REPORT TO THE CALGARY PLANNING COMMISSION

DEVELOPMENT PERMIT	ITEM NO:
	CPC DATE: 2006 February 09
	DP NO: DP2005-0884

PROPOSAL: Apartment Buildings (249 Units)	
APPLICANT: S2 Architecture	OWNER: Pointe of View
MUNICIPAL ADDRESS: 336 4 Avenue SE	LEGAL DESCRIPTION: Plan C; Block 18; Lots 12-30
AREA OF SITE 0.54 ha ± (1.34 ac ±)	
CURRENT DEVELOPMENT: Surface Parking Lot

RIVERFRONT POINT POINT OF VIEW DEVELOPMENTS		DATE: 02/09/06 DRAWN BY: [Name] CHECKED BY: [Name] SCALE: 1/8" = 1'-0" SHEET NO.: 01 PROJECT NO.: DP2005-0884	DP51.0
	SITE CONCEPT - SITE PLAN

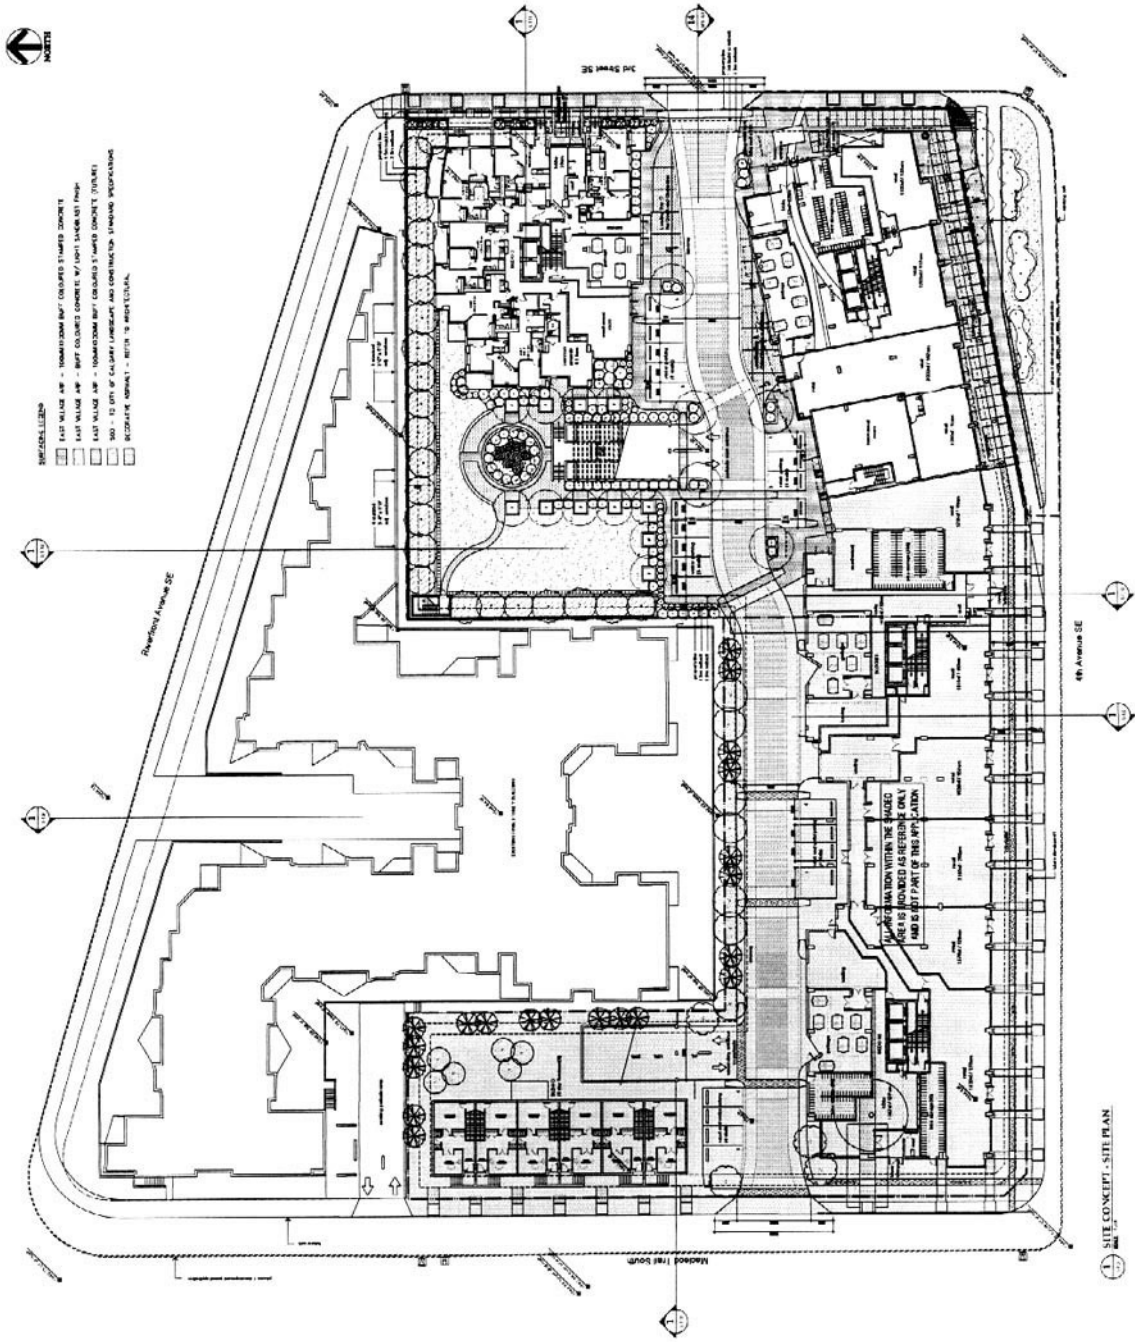
- a. Indicate surface improvements for Phase I & II on site plan
5. Request quotation and remit payment to address the requirements of the Business Units as listed below:

17. The applicant shall dimension the required right-of-way for 4 Avenue on the site plans.
18. The applicant shall supply information on the protocol for accessing the parkade for customers, visitors and tenants.

- The applicant shall provide a written statement for the operation of the parkade and more information shall be indicated on the site plan.
19. The applicant shall revise truck sweep path 2 S-6.2, eliminating trucks backing on street.

21. Transit:
 - The existing bus zone adjacent to the site on Macleod TR SE must be retained and shall be identified on all current and future site plans.
